# TECHNICAL BULLETIN

## FUSELAGE AFT SECTION AND TAILBOOM MODIFICATION

Model 600N Helicopters, serial number RN003 thru RN066 and RN068.

Analysis of the lower tailboom attach fittings and the upper longerons indicate that cracks may occur.

**Figure 1. Location of Fairings**

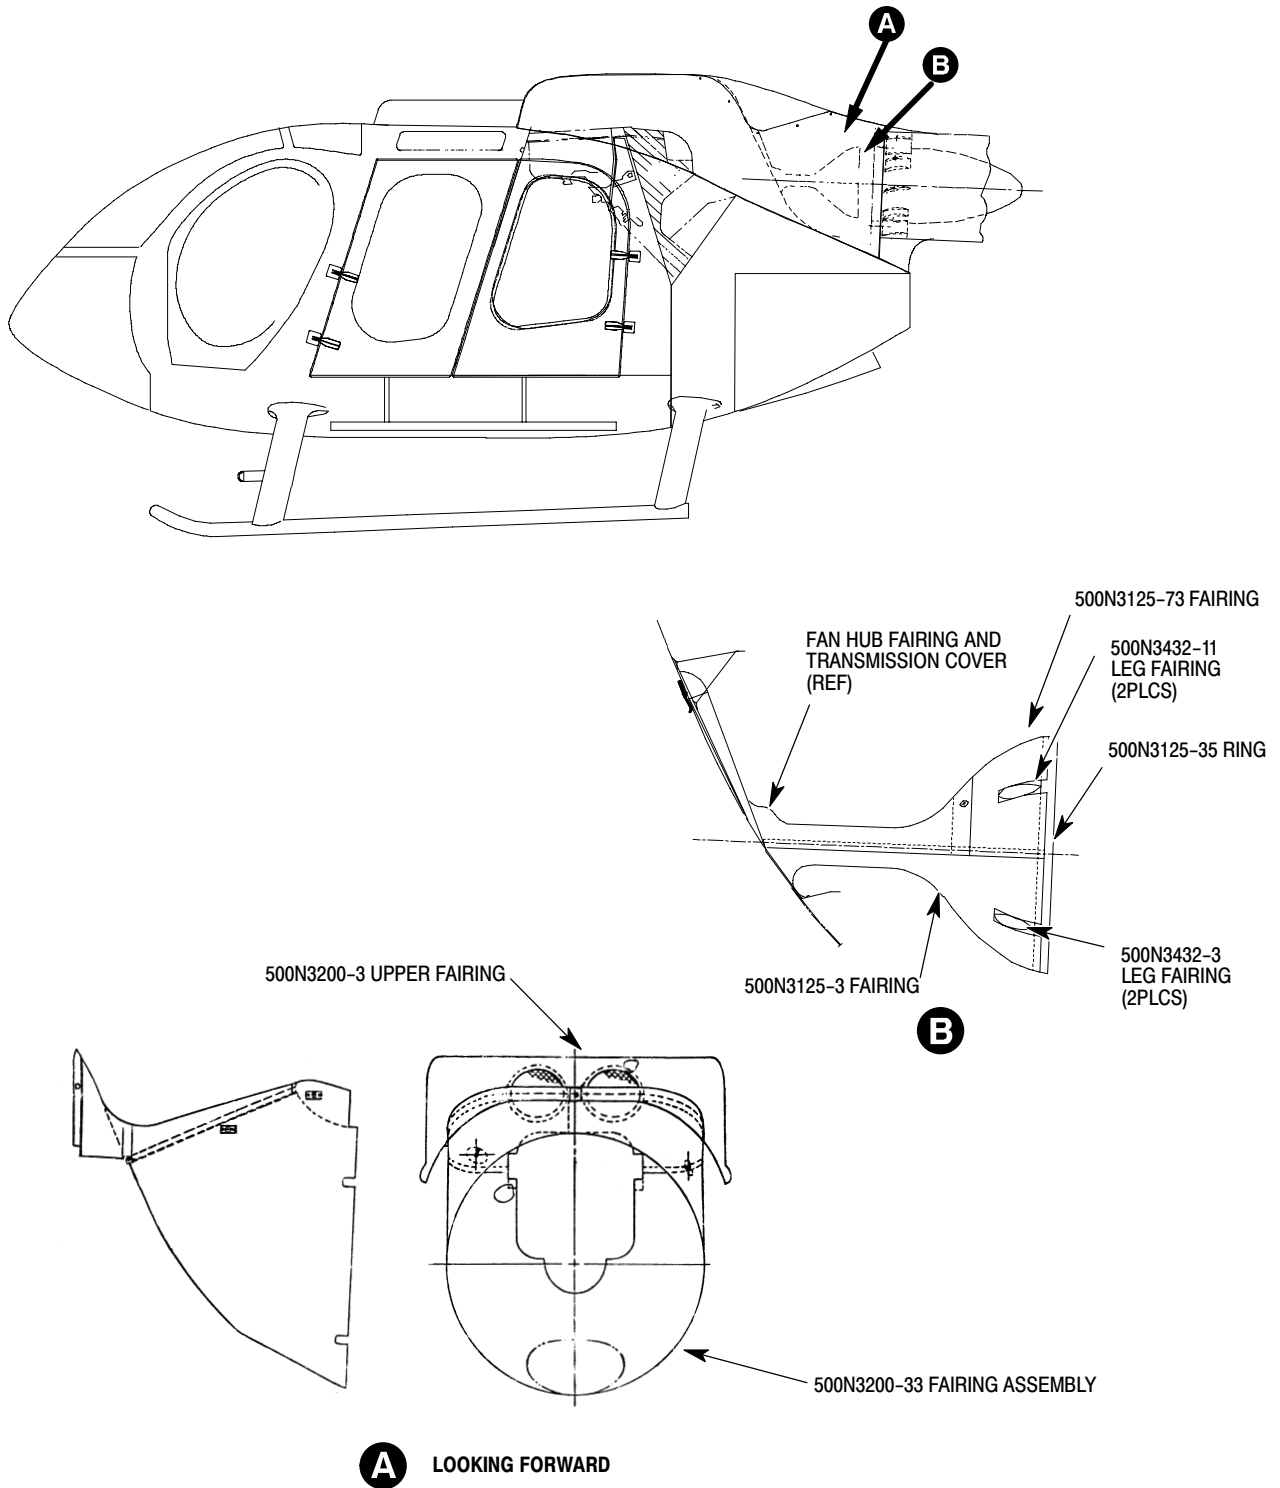
- (a). Apply heat and use a wedge to separate upper fairing (P/N 500N3200-3 and fairing assembly (P/N 500N3200-33) from forward lower end of fairing (P/N 500N3125-3).
- (b). If necessary, apply heat to adhesive bonding fairing (P/N 500N3125-73) and fairing (P/N 500N3125-3) to ring (P/N 500N3125-35) and fan support. Remove fairing (P/N 500N3125-35) and ring. Remove leg fairings (P/N 500N3432-3, -11).
- (c). Remove rivets attaching upper fairing (P/N 500N3200-3) to longerons and fan support frame.
- (d). Soften adhesive by applying heat and remove upper fairing (P/N 500N3200-3).

- (e). Remove fairing assembly (P/N 500N3200-33).
  - 1). Remove rivets attaching fairing assembly to fan support frame.
  - 2). Apply heat to bottom of forward lower edge of fairing assembly) and peel fairing away from flange.
  - 3). Apply heat to sides of fairing assembly and peel fairing away from stringers.
  - 4). Apply heat to top of aft lower edge of fairing assembly and separate from fan support frame using skin wedge.
  - 5). Remove and discard rivets, pins, collars, two fittings (P/N 500N3130-3) and tube (P/N 500N3130-7). (Ref. Figure 2, View C-C).
  - 6). Remove fairing assembly from helicopter. (Ref. Figure 1.)

- (2). Position fairing assembly (P/N 500N3200-33) in fuselage and bond bottom and sides to fuselage skin and stringers using epoxy adhesive (EA9309.3). (Ref. Figure 1.)

- (5). Install fairings.
  - (a). Attach fairing assembly (P/N 500N3200-33) to fan support frame using NAS1738B4-6 rivets .
  - (b). Position upper fairing (P/N 500N3200-3) on fuselage. (Ref. Figure 1.)

**Figure 2. Fuselage Aft Section Parts Removal and Modification (Sheet 1 of 2)**

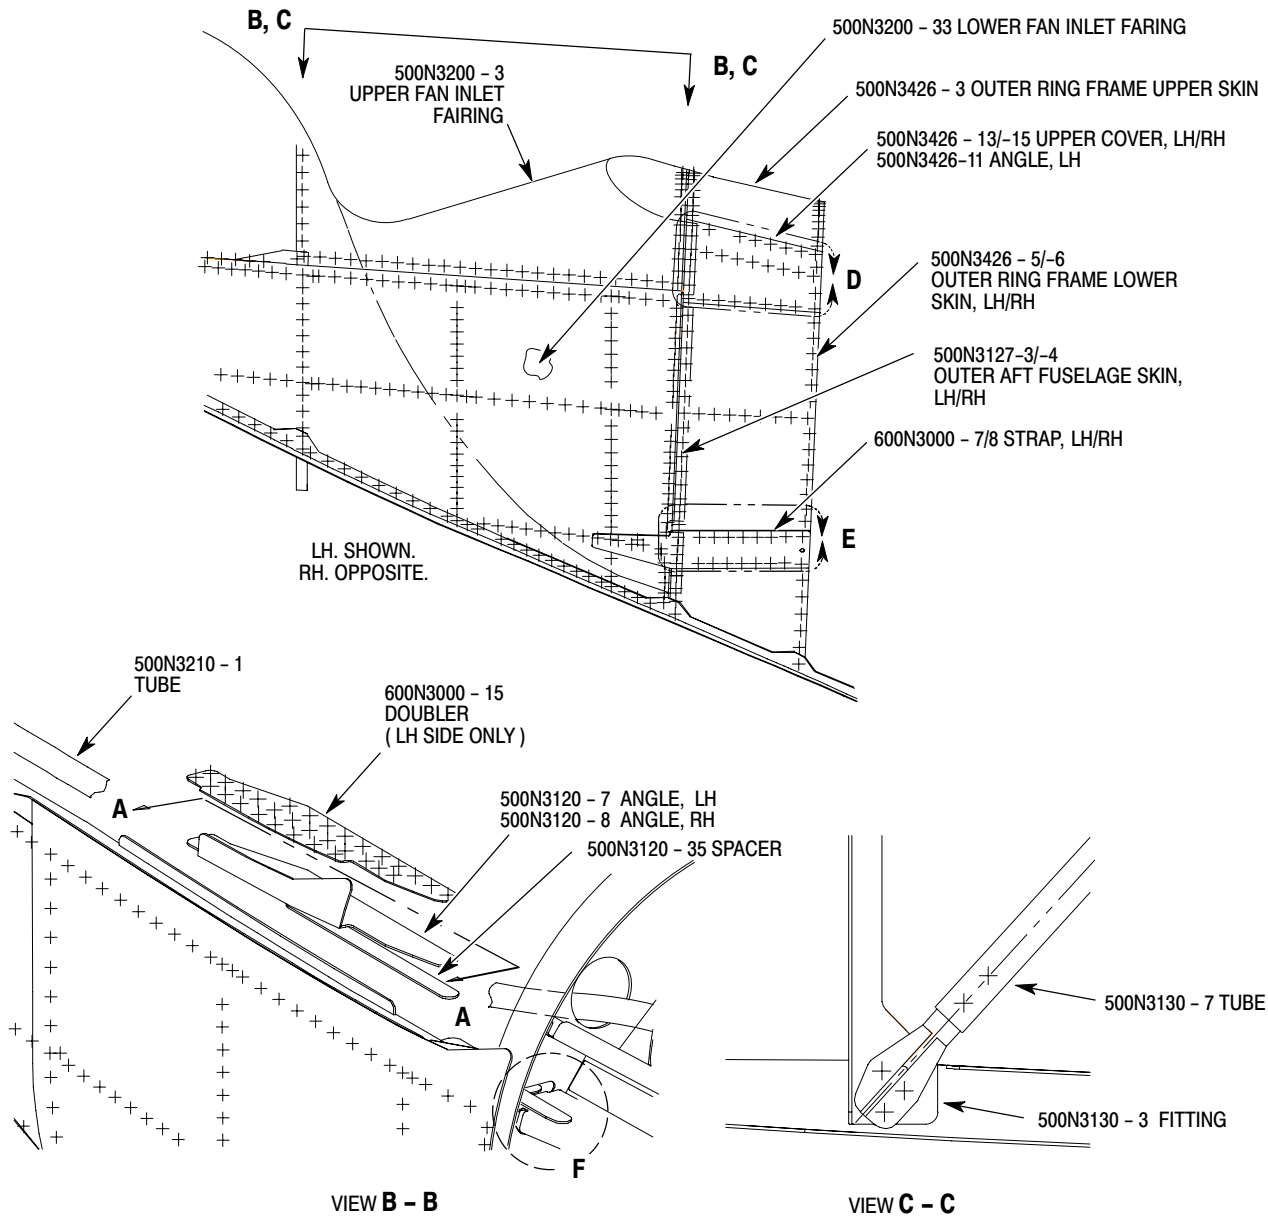
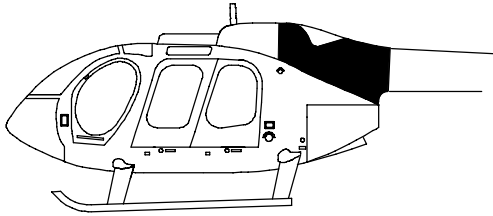
- (a). Remove rivets and remove and retain outer ring frame upper skin (P/N 500N3426-3).
- (b). Remove rivets and remove and retain LH and RH upper cover (P/N 500N3426-13/-15).
- (c). Remove rivets and remove and retain LH angle (P/N 500N3426-11).
- (d). Remove rivets and remove and retain LH and RH strap (P/N 600N3000-7/-8).
- (e). Remove rivets and remove and retain LH and RH outer ring frame lower skin (P/N 500N3426-5/-6).
- (f). Remove rivets and remove and retain LH and RH outer aft fuselage skin (P/N 500N3127-3/-4).

- (1). Remove and retain four nutplates from back of outboard facing flange of aft ring frame (Ref. Details D and E).
- (2). Remove upper and lower tailboom attach fittings.

- (a). Remove rivets and remove and discard LH upper fitting (P/N 500N3422-3) and RH upper fitting (P/N 500N3422), LH bracket (P/N 500N3429-7), RH bracket (P/N 500N3429-6), nutplates, and clip (added by Service Bulletin SB600-036). Remove and retain LH bracket, (P/N 500N3428-5) and RH bracket, (P/N 500N3428-6). (Ref. Detail D.)

- (b). Remove rivets and remove discard LH lower fitting (P/N 500N3422), RH lower fitting (P/N 500N3422-3) and nutplates. Remove and retain LH angle (P/N 500N3424-9, RH angle (P/N 500N3424-12, LH angle 500N3424-7), and RH angle (P/N 500N3424-8). (Ref. Detail E.)

- (3). If necessary, tag and de-pin wires from J208 and J513 (Ref. CSP-HMI-3, Section 96-00-00, Electrical Connectors).
- (4). Remove and retain hardware, clamp and guide tube (P/N 500N3210-1). (Ref. View B-B.)

- (5). Remove longerons and associated parts.
  - (a). Remove rivets and remove and discard LH doubler (P/N 600N3000-15, LH angle (P/N 500N3120-7), RH angle (P/N 500N3120-8), and spacers (LH and RH) (P/N 500N3120-35). (Ref. View B-B.)

- (b). Remove rivets and remove and discard angles (P/N 500N3120-9, -10) and longerons (P/N 500N3120-3, -4). (Ref. View A-A.)

**Figure 2. Fuselage Aft Section Parts Removal and Modification (Sheet 2 of 2)**

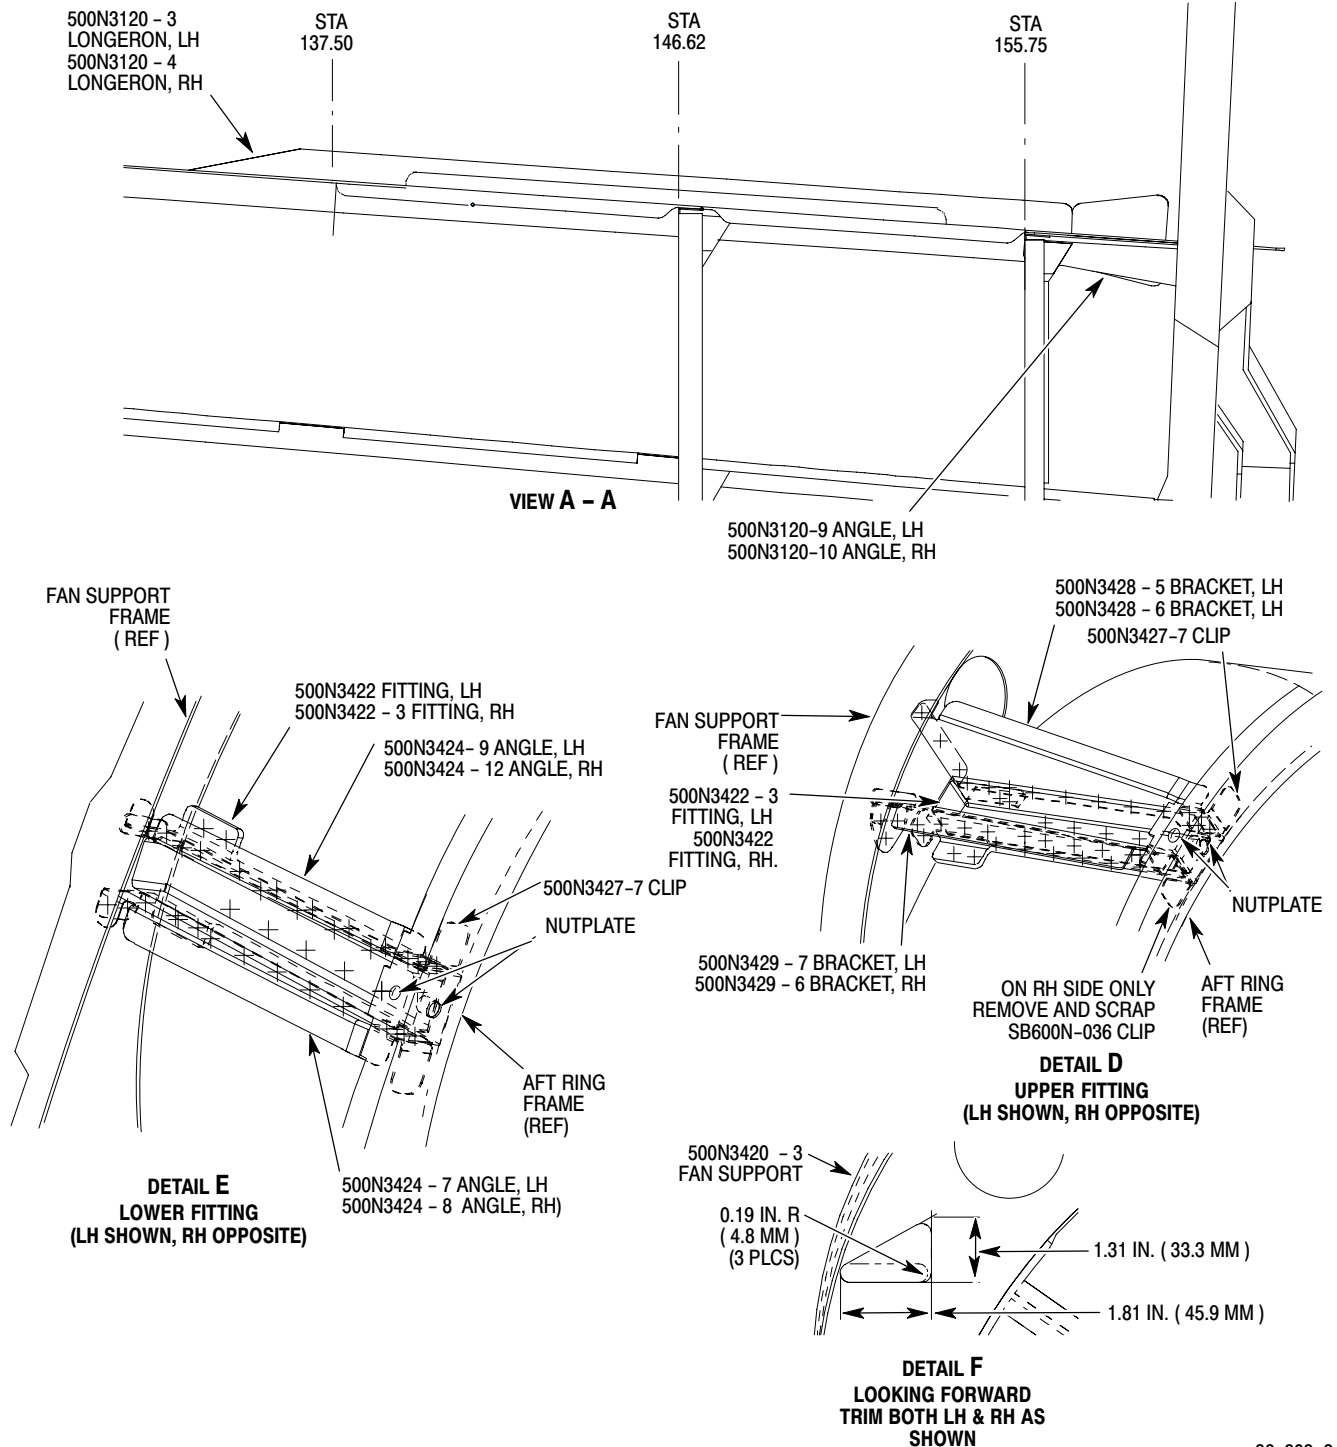
- (6). Rework fan support.
  - (a). Trim both sides of fan support as shown. (Ref. Detail F.)
  - (b). Apply chemical coating to reworked areas per manufacturer's instructions.
  - (c). Apply primer to reworked areas per manufacturer's instructions.
- (7). Install new longerons (P/N 600N3120-1/-2) and angles (P/N 500N3120-9/-10).
  - (a). Position new longerons on airframe. (Ref. View A-A.)
  - (b). Temporarily install LH and RH outer aft fuselage skins (P/N 500N3127-3/-4) and match drill attach holes in longerons.
  - (c). Match drill nutplate attach holes in longerons.
  - (d). Remove LH and RH outer aft fuselage skins.

**Figure 3. Fuselage Aft Section Modification (Sheet 1 of 5)**

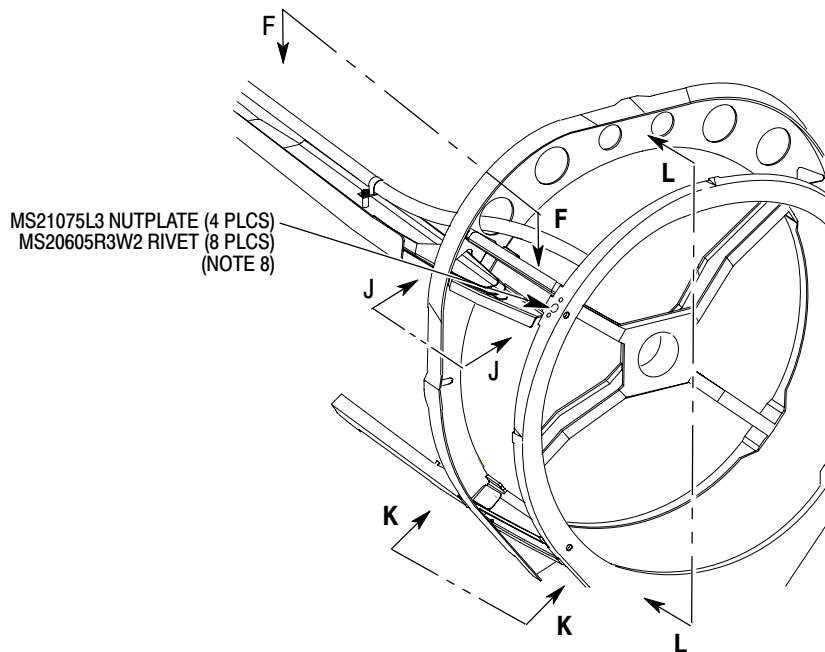
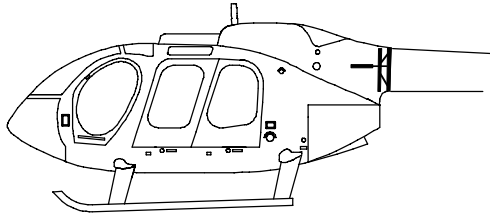
1. COLD WORK RIVET HOLES USING 4 - 0 - N SIZED TOOLING AND CBS-4-0-N SLEEVES. REAM TO 0.128 IN. ( 3.25 MM ) AFTER COLD WORK.
2. COLD WORK RIVET HOLES USING 4 - 2 - N SIZED TOOLING AND CBS-4-2-N SLEEVES. REAM TO 0.159 IN. ( 4.04 MM ) AFTER COLD WORK.

3. TRIM FITTING FOR RH. INSTALLATION AS REQUIRED TO CLEAR STRUCTURE. BLEND TRANSITIONS AND RADIUS ALL CORNERS. FINISH WITH CHEMICAL COATING AND PRIMER.

4. TRIM TO MAINTAIN 0.010 - 0.025 IN. ( 0.254 - 0.635 MM ) GAP BETWEEN 600N3120 - 1 / -2 LONGERON AND 600N3122 - 3 SPACER (REF. VIEW N)
5. SHIM AS REQUIRED WITH 2024 - T3 AL SHEET TO ELIMINATE GAP BETWEEN 600N3122 SPACER AND 500N3429 BRACKET. FABRICATE SHIM TO SPAN FROM FORWARD PIN RIVETS AND AFT TO LAST RIVET ON 600N3122 SPACER. WIDTH TO MATCH SPACER.

6. FABRICATE 0.063 IN. ( 1.60 MM ) SHIM FOR THIS RIVET LOCATION.
7. MATCH DRILL TO 600N3422 FITTING. INSTALL NUTPLATE RETAINER IN 600N3422 FITTING PER MANUFACTURERS INSTRUCTIONS PER DIMENSIONS SHOWN USING NUTPLATE RETAINER INSTALLATION TOOLING.

8. REMOVE AND RETAIN FOUR NUTPLATES. REINSTALL NUTPLATES WITH MS20605R3W2 RIVETS AFTER INSTALLATION OF TAILBOOM ATTACH BOLT NUTPLATES.
9. MHS5583-5 COLLARS MAY BE SUBSTITUTED FOR MHS5582-5 COLLARS IF THERE IS NO MISALIGNMENT AND SHORT THREAD PROTRUSION.

**Figure 3. Fuselage Aft Section Modification (Sheet 2 of 5)**

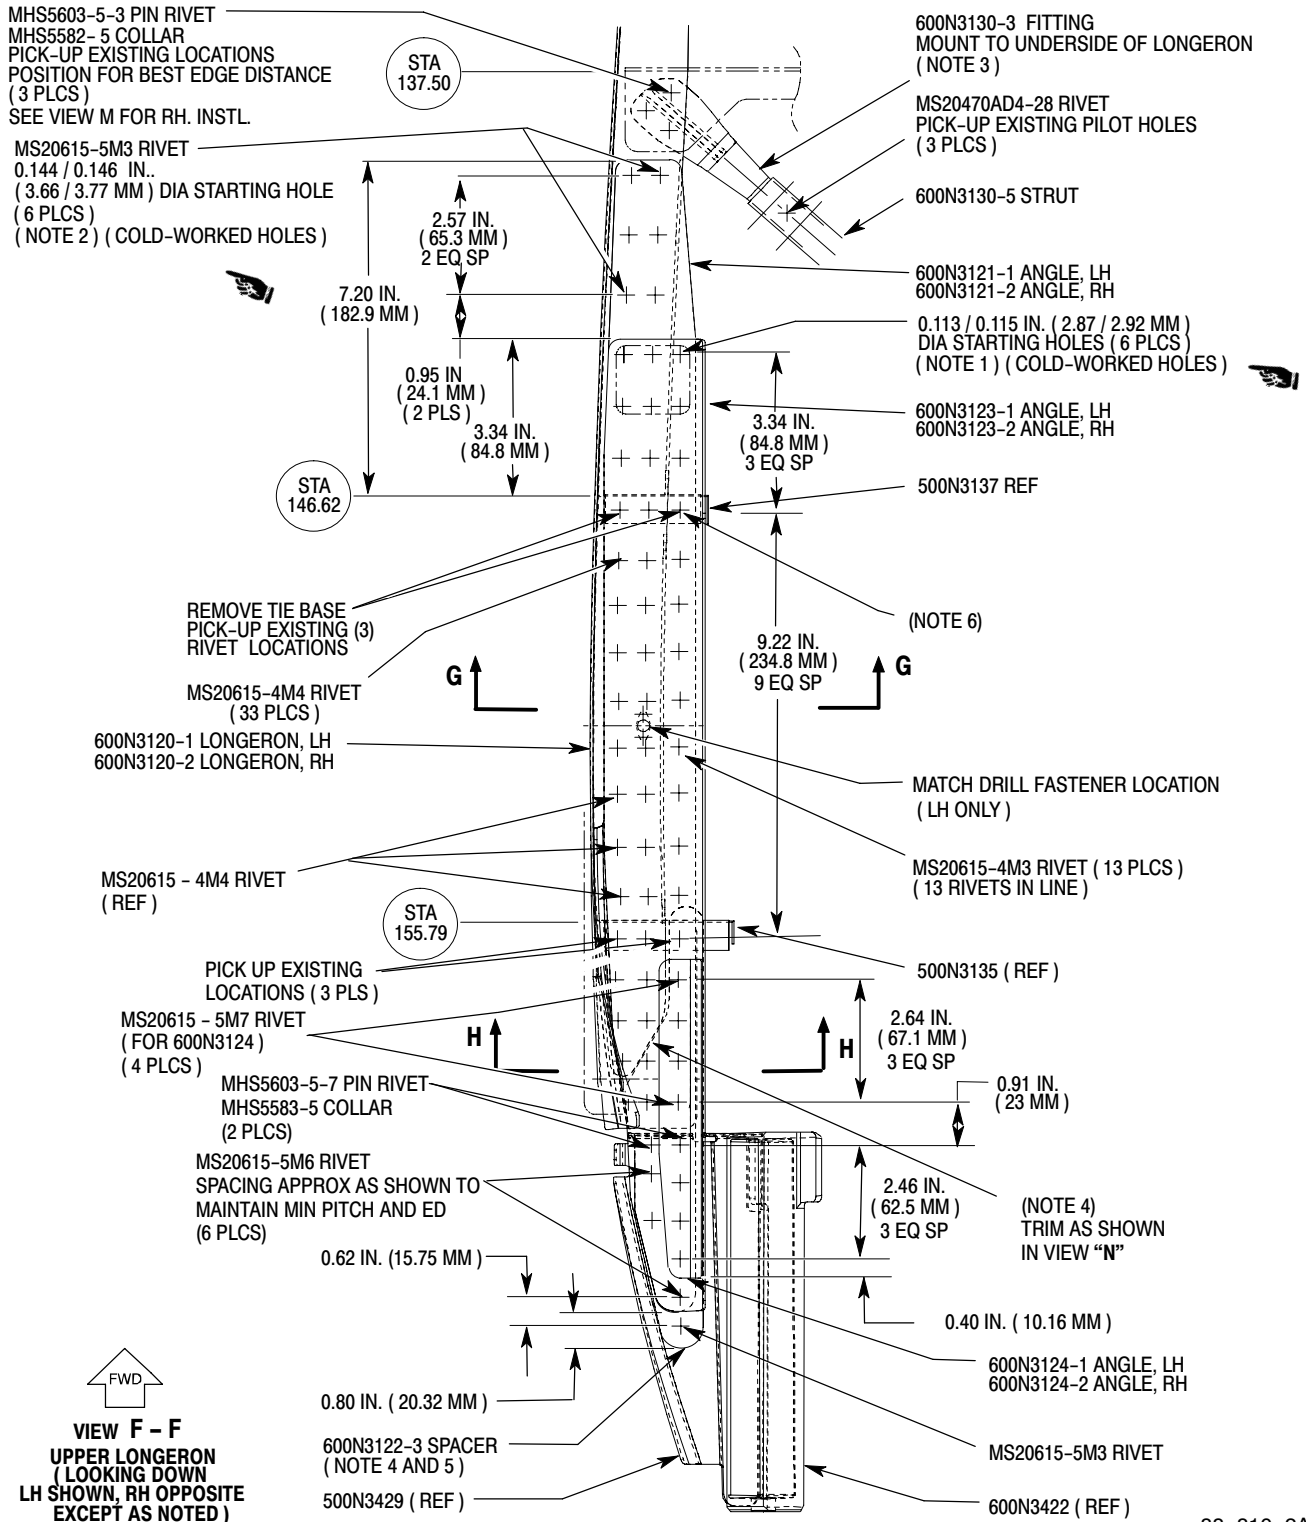
- (m). Install nutplate (P/N MS21075L3) in fitting with rivets, as shown.
- (10). Install angles and spacers.
  - (a). Layout rivet hole pattern on longerons and drill pilot holes using #40 drill bit. (Ref. View F-F.)
  - (b). Position aft section angles (P/N 600N3121-1/-2), spacers (P/N 600N3122-3), angles (P/N 600N3123-1/-2) and angles (P/N 600N3124-1/-2) in position on longeron as shown and clamp securely into place. (Ref. Section H-H.)

- Maintain 0.010-0.025 inch (0.254-0.635mm) gap between longeron and spacer (P/N 600N3122-3).
- Shim as required with 2024-T3 aluminum sheet to eliminate gap between spacers (P/N 600N3122-3) and brackets (P/N 500N3429-9/-10).
- Fabricate 0.063 inch (1.60 mm) shim for specific rivet location as shown. (Ref. View F-F.)
  - (c). Transfer holes to all angles and spacers.
  - (d). Drill and cleco rivet holes through angles and spacers. (Ref. View F-F.)
  - (e). Remove angles and spacers and deburr rivet holes. Touch up with primer as needed.
  - (f). Install longerons in airframe and install nutplates on longerons.
  - (g). Match drill and temporarily install angles (P/N 500N3120-9/-10).
  - (h). Install angles and spacers on longerons and attach with rivets, as shown. (Ref. View F-F.)
  - (i). Permanently install LH and RH outer aft fuselage skins (P/N 500N3127-3/-4).

- (j). Cold work 12 rivet holes (each side) using proper sized tooling.
- (k). Install 12 rivets (Ref. Sheet 2 of 5)
- (11). Using drill fixture 600N3510-1-DJ1, enlarge four tailboom attach holes in aft ring frame. (Ref. View L-L.)
